Application to the HISTORIC DISTRICT COMMISSION, Nantucket, Massachusetts, for a

CERTIFICATE OF APPROPRIATENESS for structural work.

TAX MAP N°: 55.4.1 PARCEL N°: 41
Street & Number of Proposed Work: 15 WARDEN STREET
Owner of record: PAULINE + LARRY BOLAN
Mailing Address: 15 WARDEN ST.
NANTUCKET, MA 02584
Contact Phone #: _____ E-mail: _____

BOGAN-15 WARREN ST
REV TO PREVIOUS APPROVAL (2020-01-0550)
KEEP DOOR AS 6 PANEL (WITH 2 LIGHTS)

PROPOSED REV TO SOUTH ELEVATION

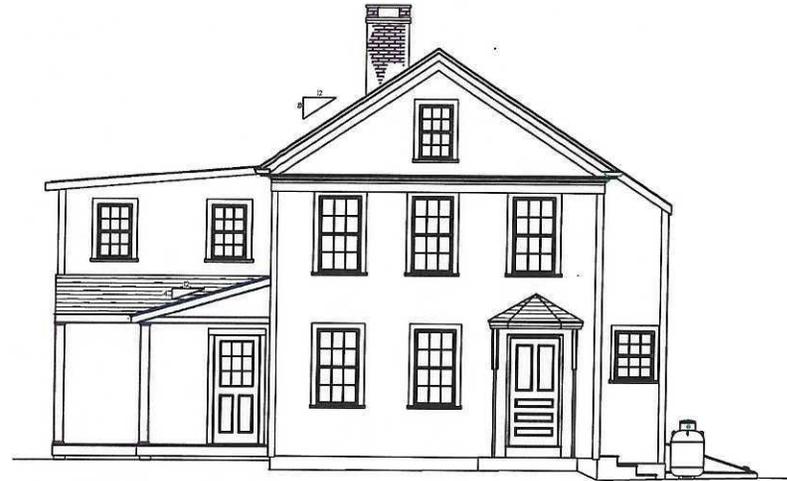
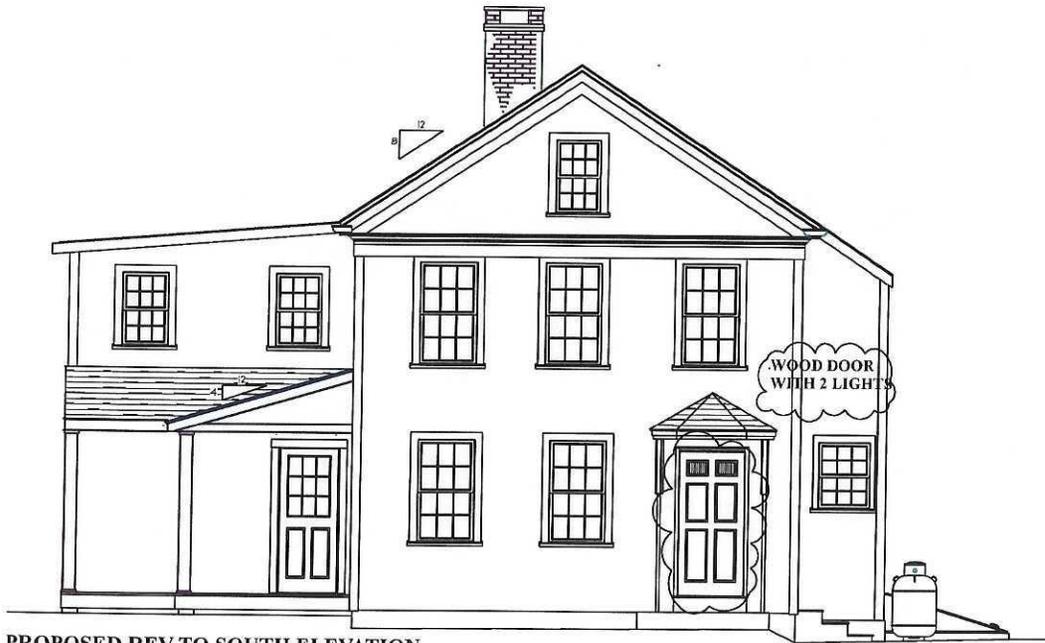
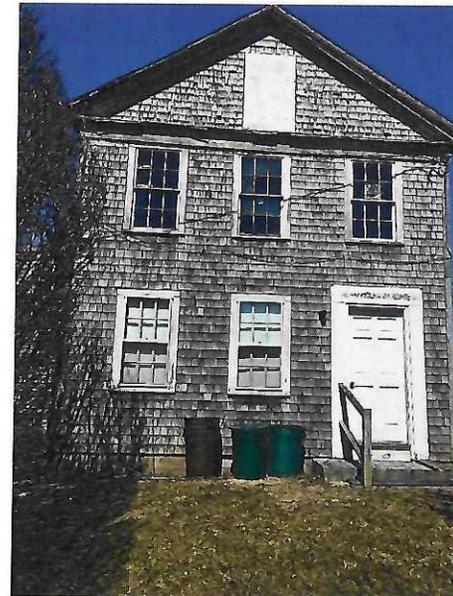
Handwritten note in cloud: REPLACE DOOR TO PANEL INSTEAD OF REPLICATING HISTORIC DOOR
